Approved Minutes of the Sixth Meeting of the ER P28 Joint GCRP and DCRP Working Group

4th November 2015

5. Review Amendments to Phase 2 Review Report for ER P28 – Recommendations for Revision

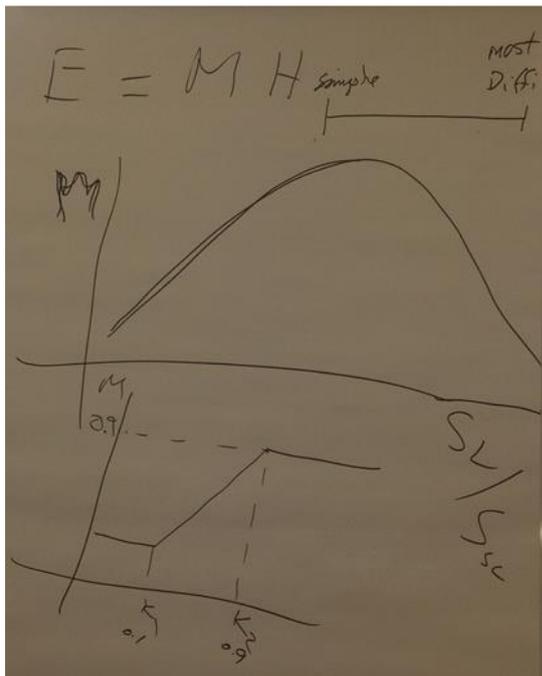
FG drew the two diagrams to help explain the proposed changes

There are problems with the top diagram given the M reduces beyond a certain value of connected load/generation

The bottom diagram shows the proposed changes where the value of M reaches a maximum value for a certain value of connected load/generation. The intention is this can be applied to flicker and harmonics

It was agreed the sub-WG should debate how to define K_1 and K_2 on the bottom axis

DV was concerned the proposal does not cater for system capacity, noting capacity is not directly linked to fault level. It was thought there is merit in addressing system capacity (including future capacity) in some respect which may require more rules around capacity. Why would you only allow 50% of headroom when there is no capacity? Is it possible to have a parallel process that takes into account fault level and system capacity? How will changes to future capacity be addressed?

It was agreed there are many challenges to work through and whether the proposed simple approach can be justified.

ACTION 6.10: Document challenges of proposed approach to allocation of rights (DV)
